TRANS/WP.29/650
16 February 1999

DRAFT SUPPLEMENT 2 TO THE 03 SERIES OF
AMENDMENTS TO REGULATION No. 44

(Child restraints)

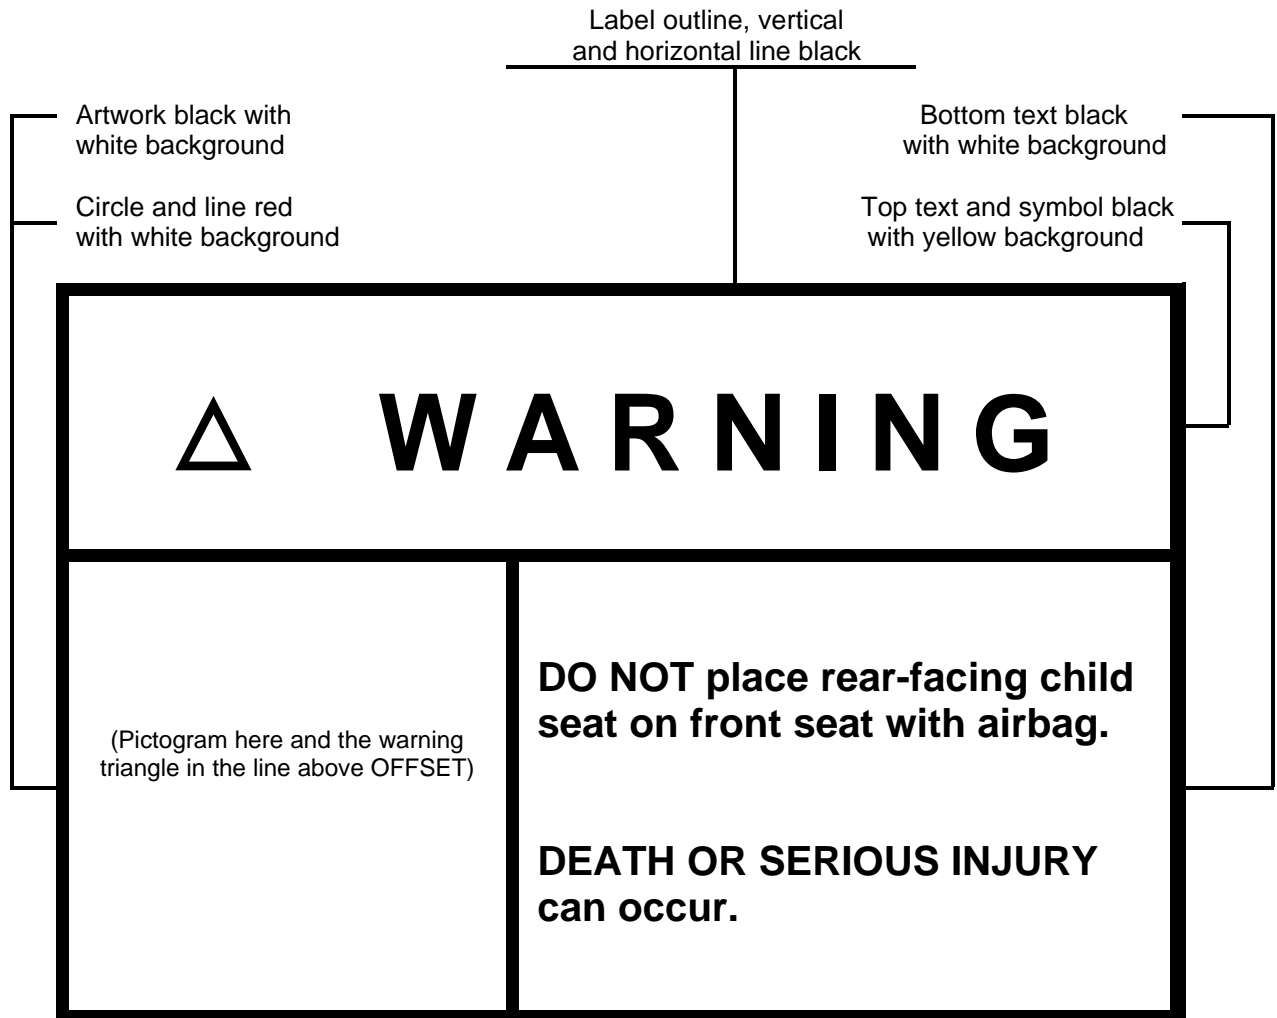
Insert a new paragraph 4.5., to read:

"4.5. In addition, in the immediate area where the child's head rests within the child restraint and on the visible surface of the child restraint system, rearward-facing restraints shall have the following label permanently attached (the text information shown is

a minimum).

This label shall be provided in the language(s) of the country where the device is sold.

Label minimum size: 60 x 120 mm
